ADDENDUM

02

Lancaster Township Police Department
Renovations & Addition
Lancaster, PA

Date of Addendum: 13 September, 2024
Marotta/Main Architects Project No.: 24-LT-01

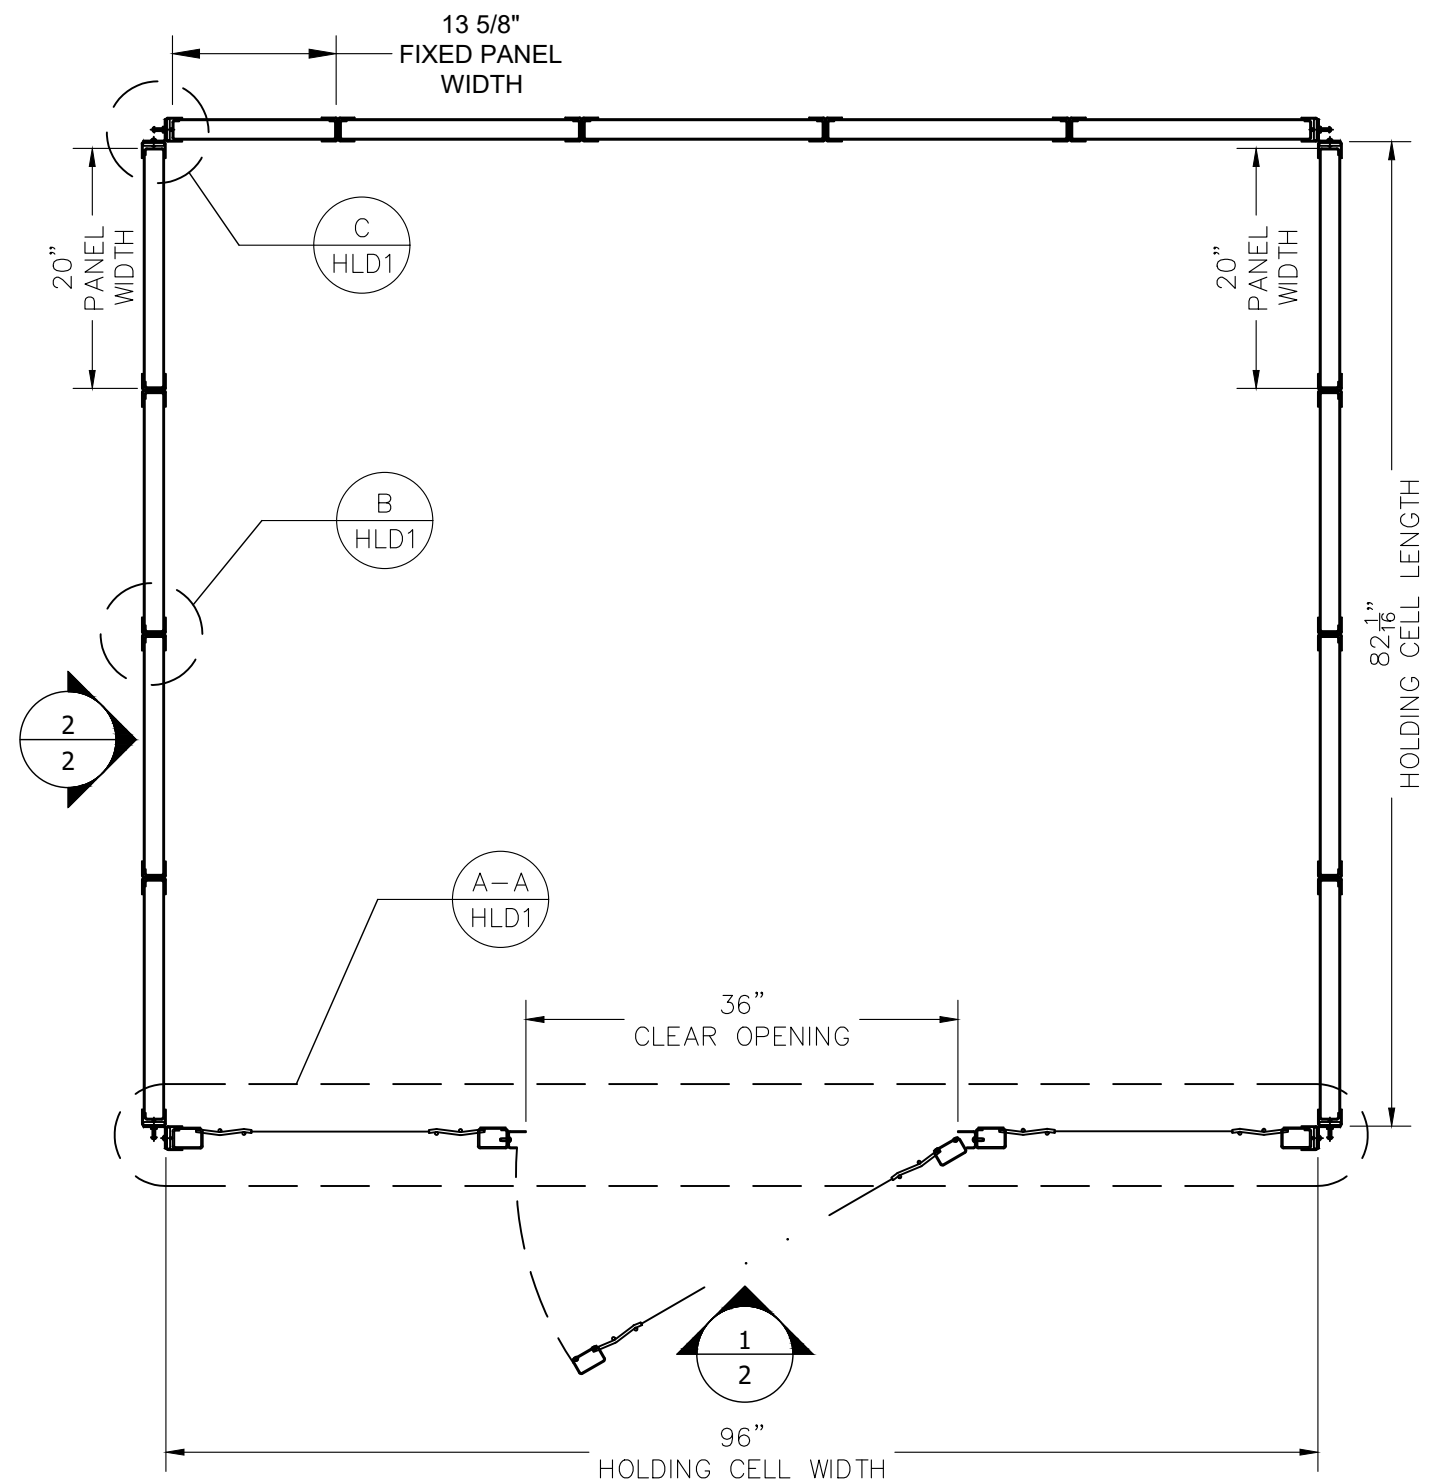
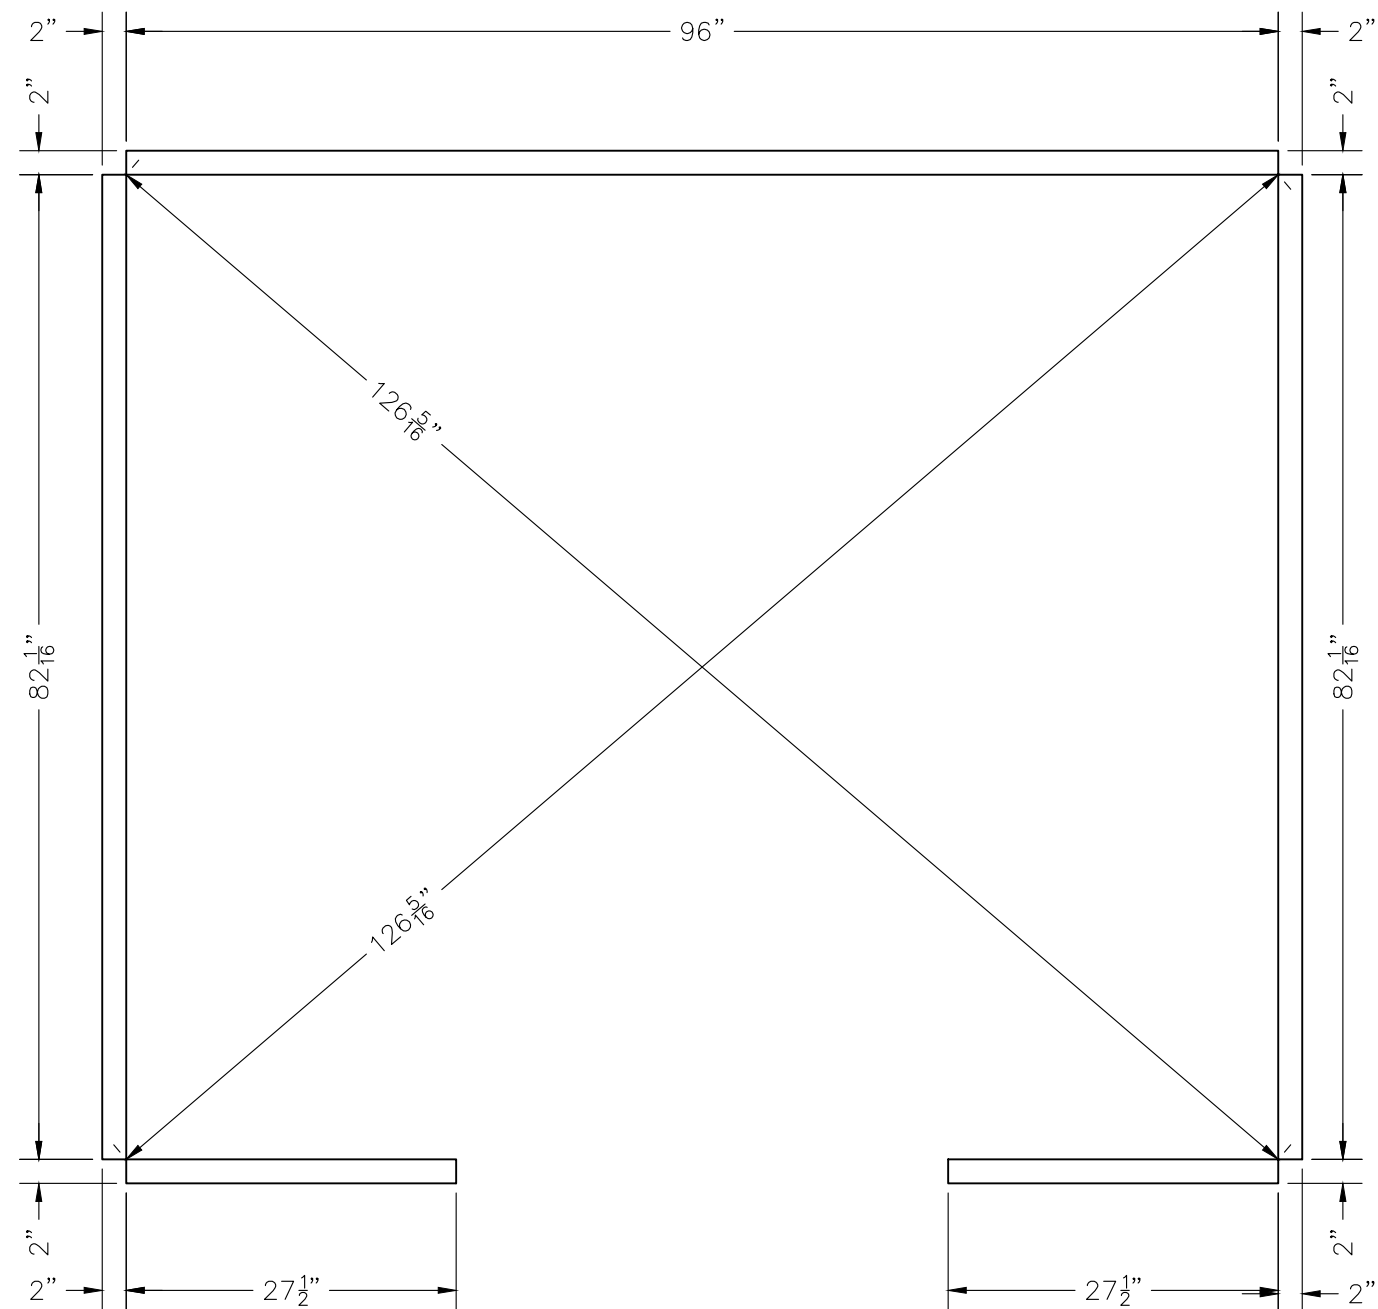
- 02.08 Refer to Drawing P0.1 PLUMBING COVER SHEET, ADD the following product list as Basis-of-Design products:
'Provide the following or equal products:
Lavatory faucet.
a. Moen 8434 Faucet with chrome finish & drain covers
Water heater mixing valve
b. Watts LFMMVM1-UT 0559119 ¾" thermostatic mixing valve
Shower valve faucet and trims
c. Kohler – Coralais Rite Temp – K-TS15611-4G
Floor drain and clean out in garage
d. ULMA D100 drain channel w/ 486 slotted fiberglass grate – Class B w/ locking device, end caps and end outlet, 6"x10'; Clean out - Sioux Chief - 852 series 4" w/ cast iron heavy-duty cover
Note: Pex is not acceptable for the whole domestic water system. Only piping ¾" and smaller.'
